NRC – Callaway / Wolf Creek Public Meeting

GL 2004-02 Response RAIs
November 20
2009

- The purpose of this presentation is to address GL 2004-02 RAIs for Union Electric Company (Callaway) and Wolf Creek Nuclear Operating Corporation (Wolf Creek).

Material Deposition Observations Test 3B – Wolf Creek Design Basis Test

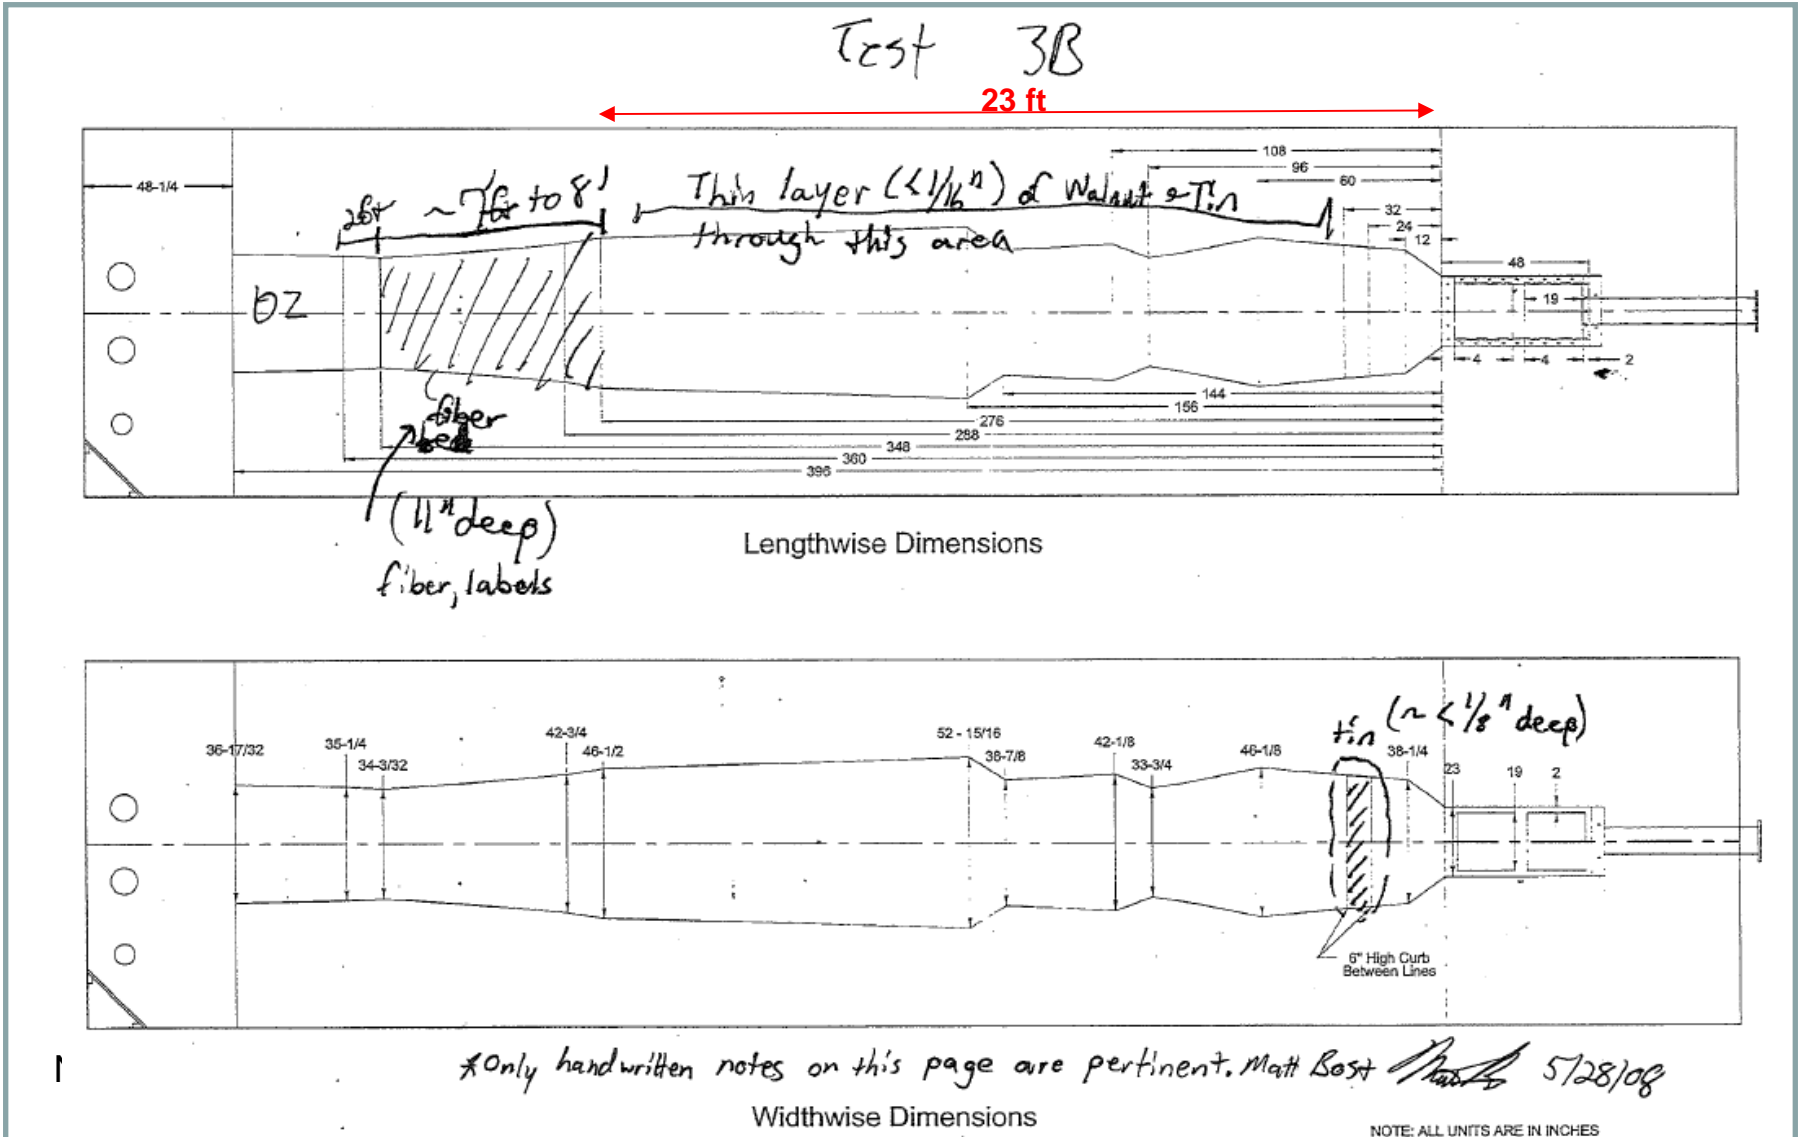
- Differences in flow patterns near sump pit between Debris Transport CFD and Large Flume CFD were attributable to resolution of flow near the sump and the detailed modeling of the strainer array.
- Higher velocities predicted near sump pit demonstrated in subsequent CFD modeling conducted in response to RAI #27 did not affect the validity of the Wolf Creek and Callaway Design Basis Testing since debris settling was not observed in the test flume within 13 ft of the test strainer where the velocities were predicted to be higher.
- Conclusion: Even though the test flume velocities near the strainer were less than predicted by the refined CFD, the testing was bounding.

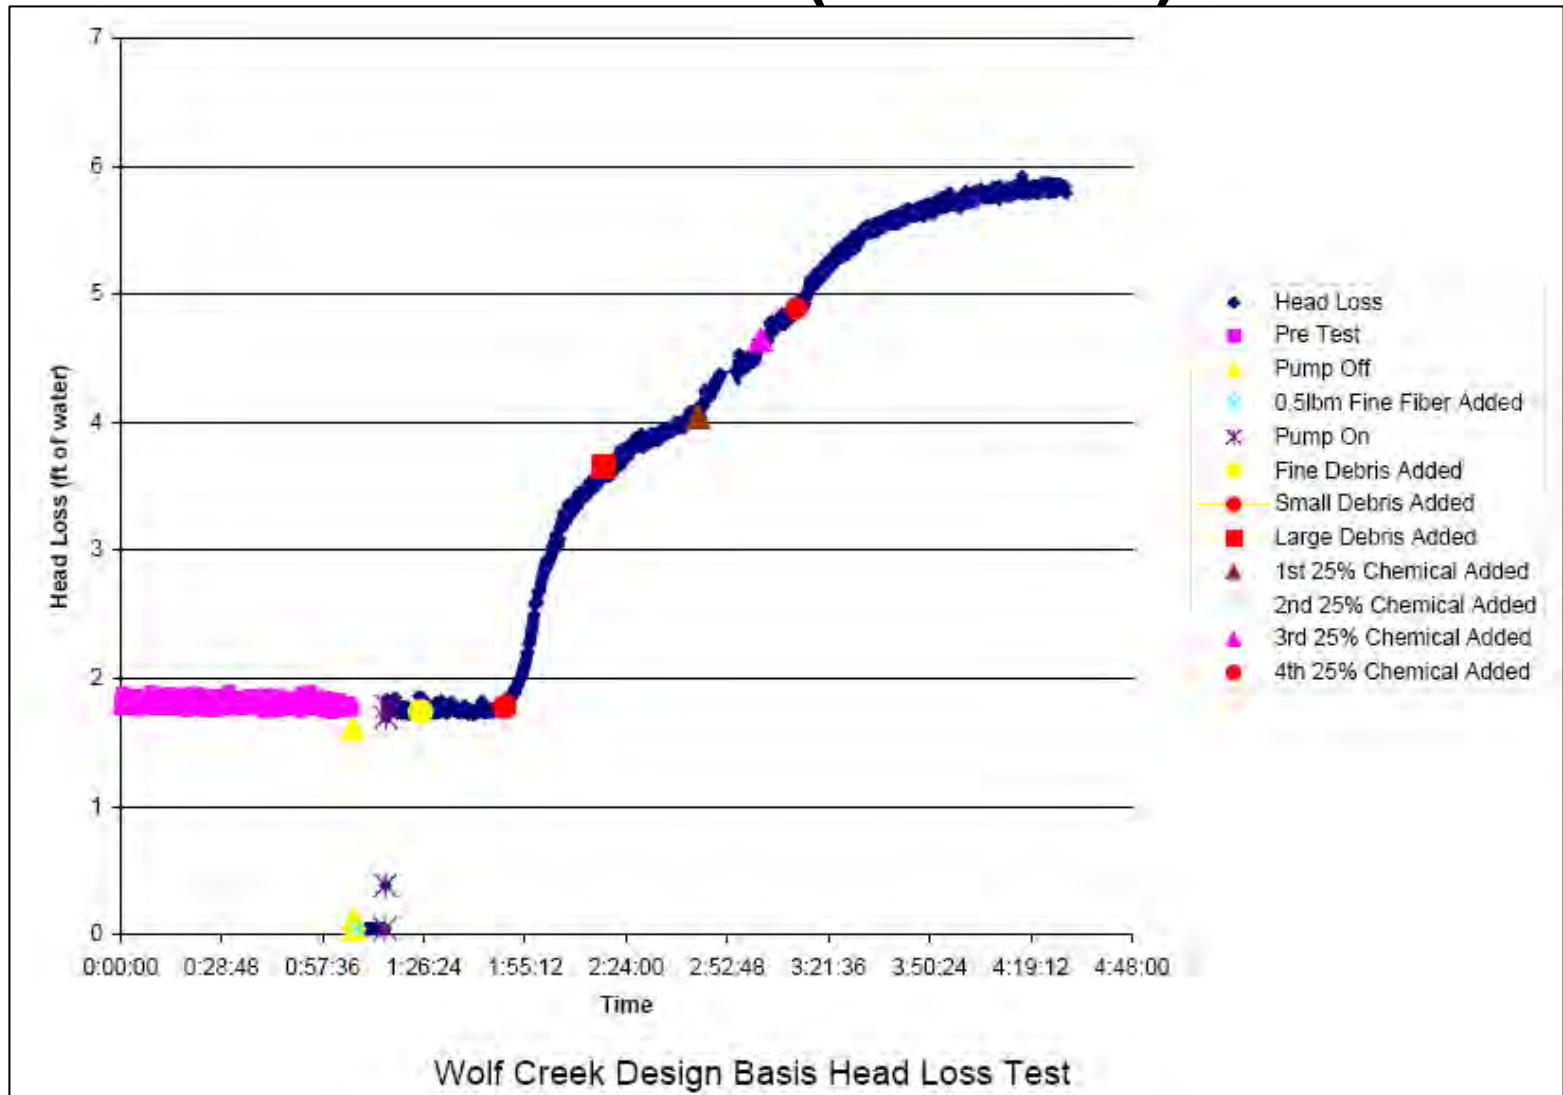
- The head loss testing for WC/CNP did account for erosion of this debris due to
 - Increased velocities from the decreased flow area over the settled debris
 - Fibers separated upon introduction into the flume, as shown in the video
 - The head loss curves shows large increase in head loss which we believe is related to fine fibrous debris being transported to the screen, which would include any erosion – see figure below
- No fiber was observed to settle within 23 ft. downstream of the debris accumulation

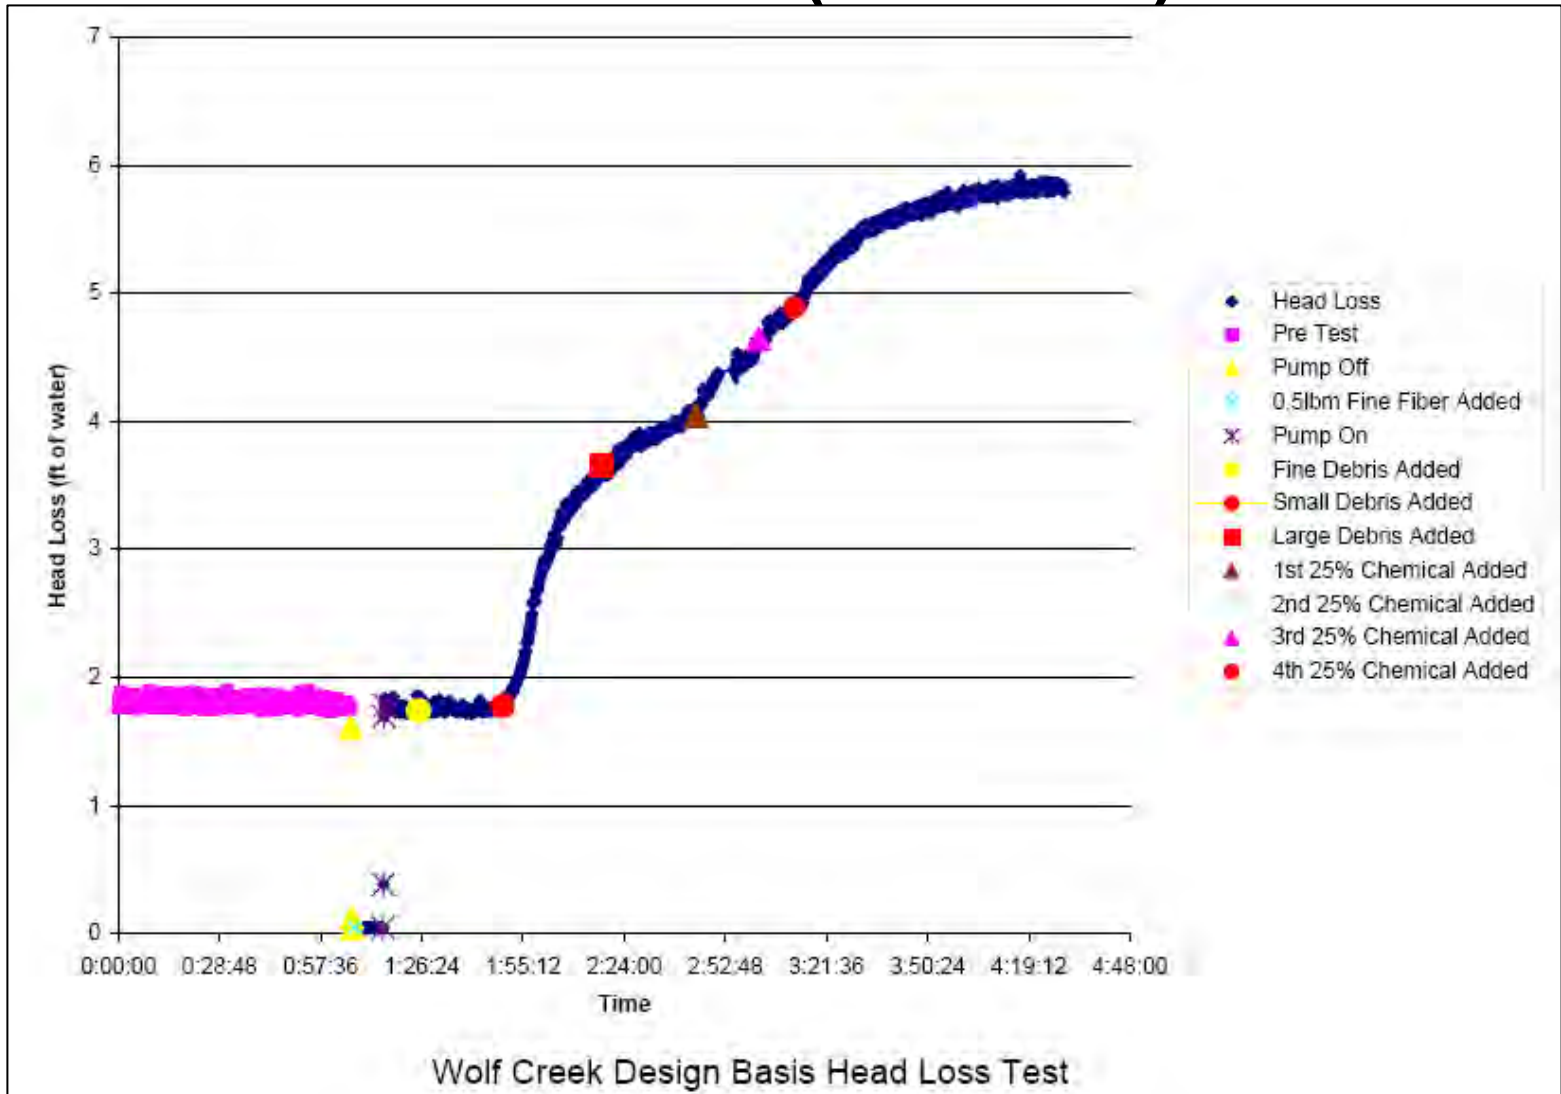
- Two pool turnovers between addition of next debris types – so adequate time (7 min) available to transport material.
- The introduction sequence did not affect the test results, since subsequent head loss testing shows a significant jump in head loss when the small fines mixture was added. See figure below from RAI #22.

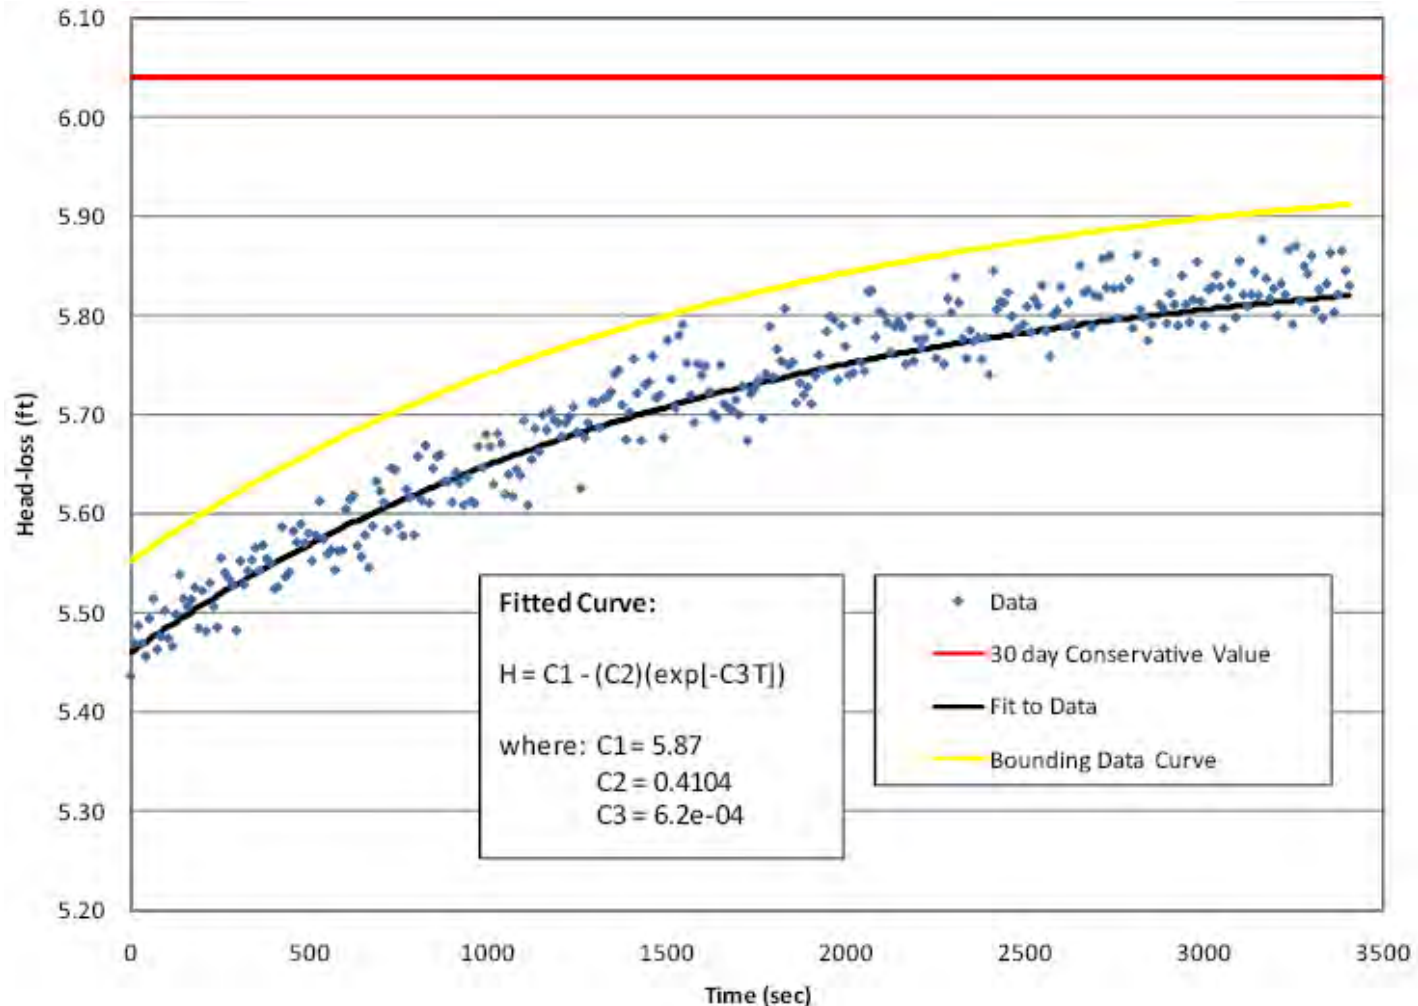
- The head loss extrapolation makes no assumptions about the particular thickness of the debris bed

Wolf Creek 30-day head loss curve

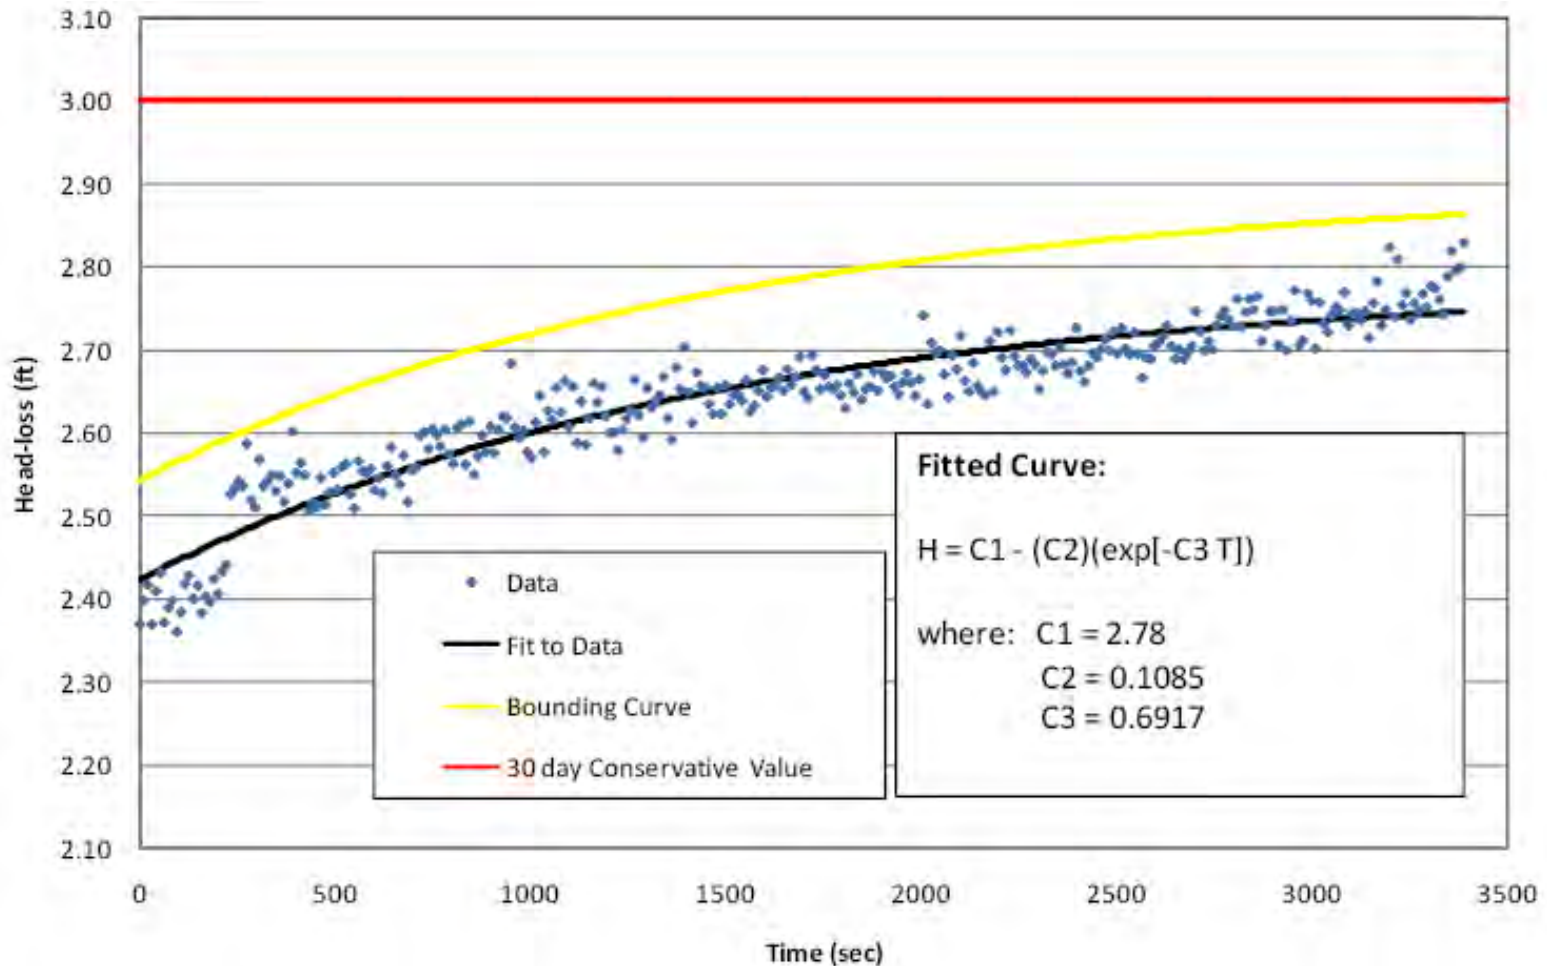
- A more detailed look at the data fit is given in the following graphs
 - The data is shown along with the mean fit and a statistically meaningful bounding curve to all collected data points
 - The 30 day head loss value used in further analysis is based on the extrapolated head loss determined from the data-bounding curve
- For conservatism, additional margin was added
 - The maximum difference between the mean curve fit and any data point is added to the bounding curve value (yellow line)
- The resultant 30 day head loss value is shown as a red horizontal line at 6.04 ft for Wolf Creek and 3.00 ft for Callaway
